UNITED STATES PATENT AND TRADEMARK OFFICE

APPLICATION NO.	FILING DATE	FIRST NAMED INVENTOR	ATTORNEY DOCKET NO.	CONFIRMATION NO.
10/630,295	07/30/2003	Gilberto Goncalves Oliveira Filho	138330	9716

Office Action Summary

DETAILED ACTION

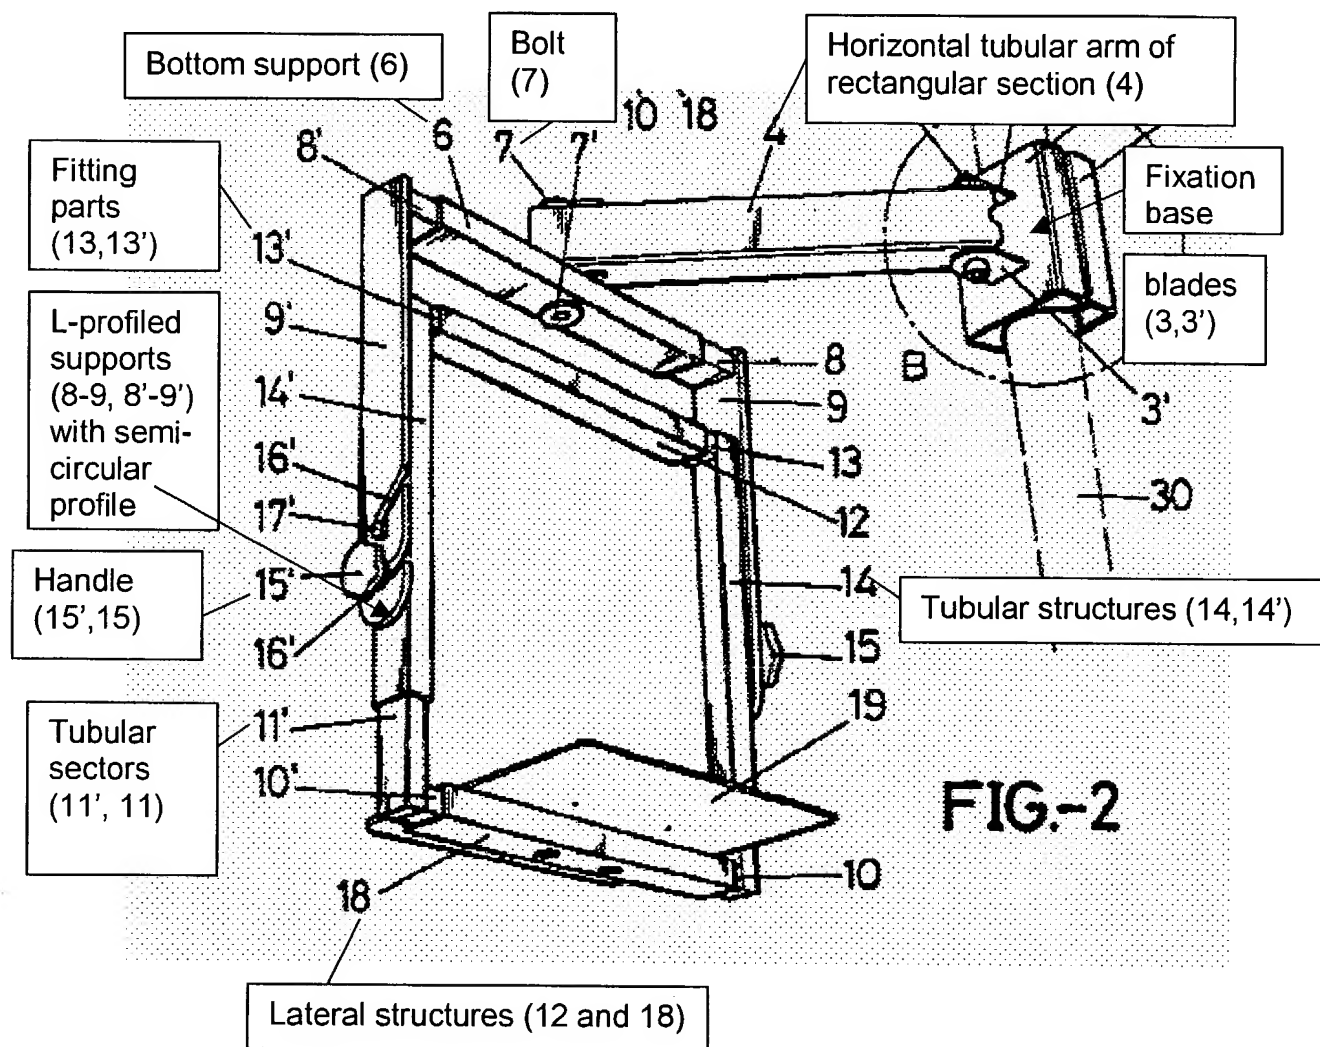
Claims 1, 2, 5, 6, and 8 are rejected under 35 U.S.C. 102(b) as being anticipated by Canton Gongora et al (US patent no. 5,797,568). Gongora disclosed all the claimed features of applicant's invention. (See examiner's illustration below)

Claims 3, 4, 7, and 9-11 would be allowable if rewritten to overcome the rejection(s) under 35 U.S.C. 112, second paragraph, set forth in this Office action and to include all of the limitations of the base claim and any intervening claims.
